RARE OILFIELD SERVICES 502 MITCHELL DRIVE SE REDCLIFF, ALBERTA, T0J 2P0	RARE EQUIPMENT #		DRAWING TITLE		FILE NAME		
					15780- FLARE KNOCK OUT DRUM		15780- FLARE KNOCK OUT DRUM FLOAT CHAMBER MODIFICATION		15780 FLOAT CHAMBER		
A	MODIFICATION OF ORIGINAL FLOAT CHAMBER				KH	2026/09/10			LAYOUT NAME		
REV	DESC				BY	DATE			SHT 1		
REVISIONS									REVISION		
						DATE		DRAWN BY		REVISION DATE	
						SEPT 10, 26		K HOBMAN		A

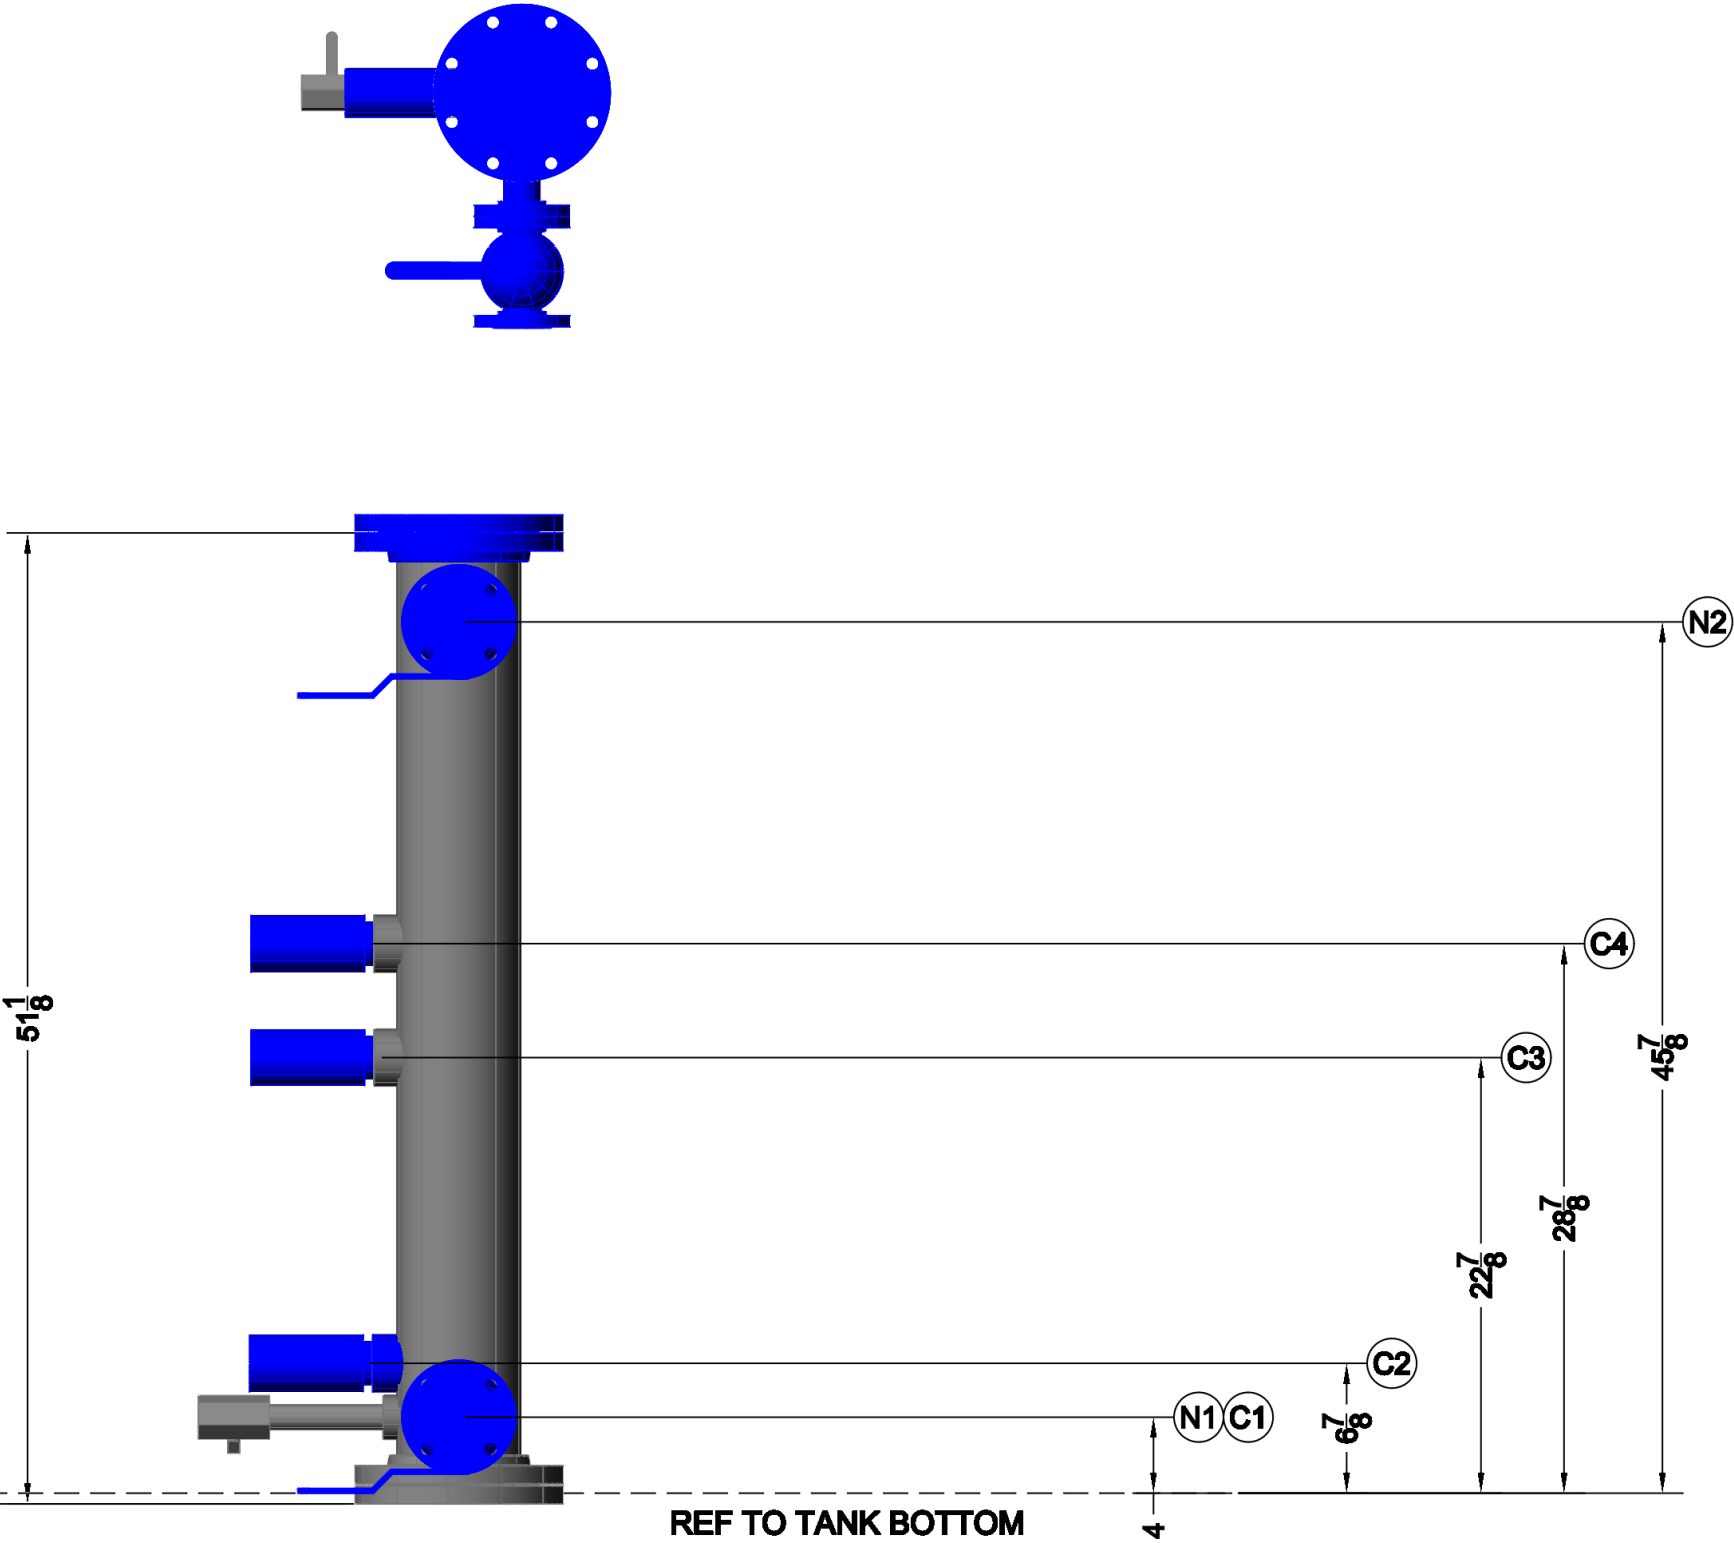
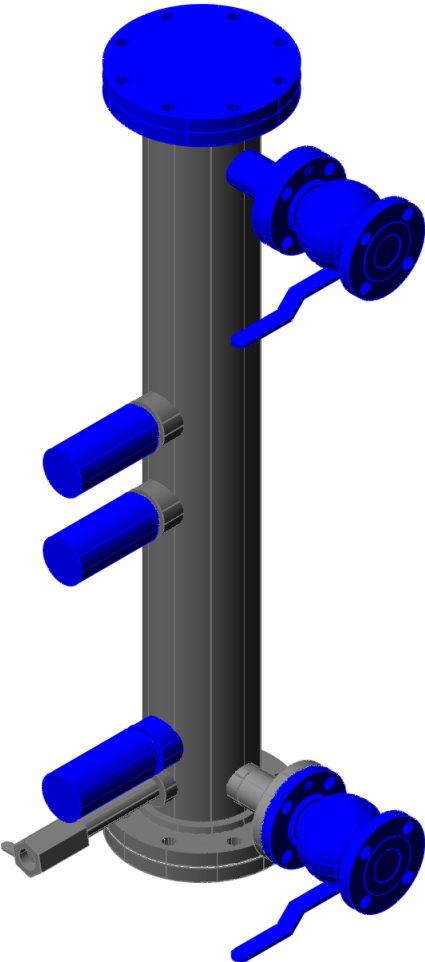
NOTES:
1) ALL ITEMS IN BLUE ARE NEW
2) CUT DOWN EXISTING FLOAT CHAMBER AS SHOWN
3) ADD N2 AND C3 AS SHOWN
4) LEVEL CONTROLLER INSTALLED IN FIELD
5) TWO ISOLATION VALVES REQ, 2" 150# REG PORT.
6) C3 AND C4 ARE EXISTING, IF THE LOCATION IS NOT SATISFACTORY
NEW HALF COUPLING CAN BE INSTALLED.
